### Iron Dust Off By-Pass R.OW. Subdivision

City Plan Commission — September, 25, 2025

CASE NUMBER/TYPE: SUSU25-00052 – Major Combination

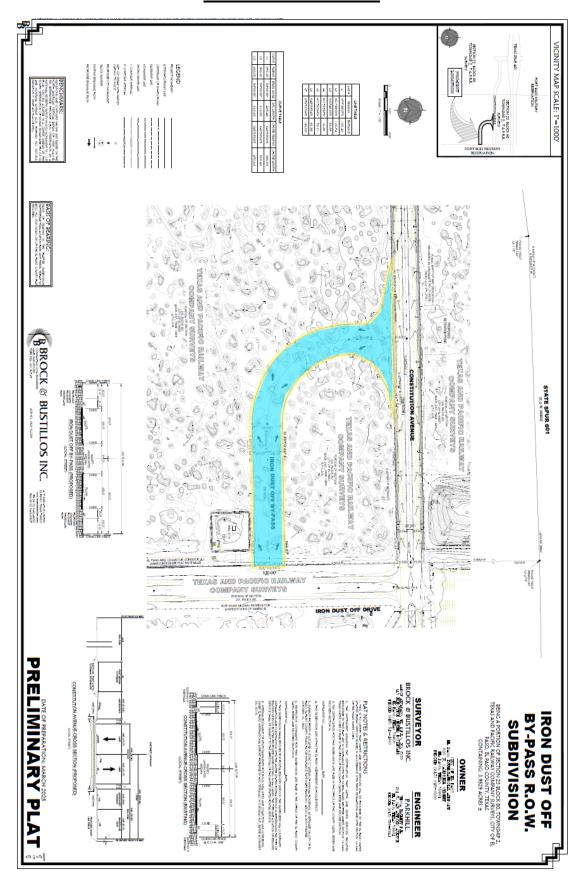
- 1. Submit to the Planning & Inspections Department Planning Division the following prior to recording of the subdivision:
  - a. Current certificate tax certificate(s)
  - b. Current proof of ownership.
  - c. Release of access document, if applicable.
  - d. Set of restrictive covenants, if applicable.
- 2. Every subdivision shall provide for postal delivery service. The subdivider shall coordinate the installation and construction with the United States Postal Service in determining the type of delivery service for the proposed subdivision. In all cases, the type and location of delivery service shall be subject to the approval of the United States Postal Service.
- 3. Provide temporary turnaround easement at the end of Iron Dust Off By-Pass.

There is limited water and sanitary sewer capacity in the area. EPWater requests the anticipated water demand and sanitary sewer flows before committing to provide service.

There is an existing 16-inch diameter flow line that extends through the east portion of the property. No direct service connections are allowed to this main.

There are no sewer mains available for service in the vicinity of this area.

- 1. Provide a conceptual Drainage Plan indicating existing and proposed major stormwater facilities as per Section 19.02.020 of the Municipal Code.
- 2. Identify the final location of all the stormwater runoff. Developed runoff needs to be contained within the land owned by the developer of this street. Any proposed ponding area shall have enough capacity to hold the developed runoff for a designated 100-yr. storm event.
- 3. At the improvement plan stage, provide protection to the subdivision from all offsite storm water runoff that may have an adverse impact on any improvements and convey the existing watercourse through the subdivision.

Since the Traffic Control Plan (TCP) and the replacement of existing signs on Spur 601 are included in the plans, any work within TxDOT ROW will require a permit before it can start.

Please submit a TxDOT permit application for any work proposed within the ROW.
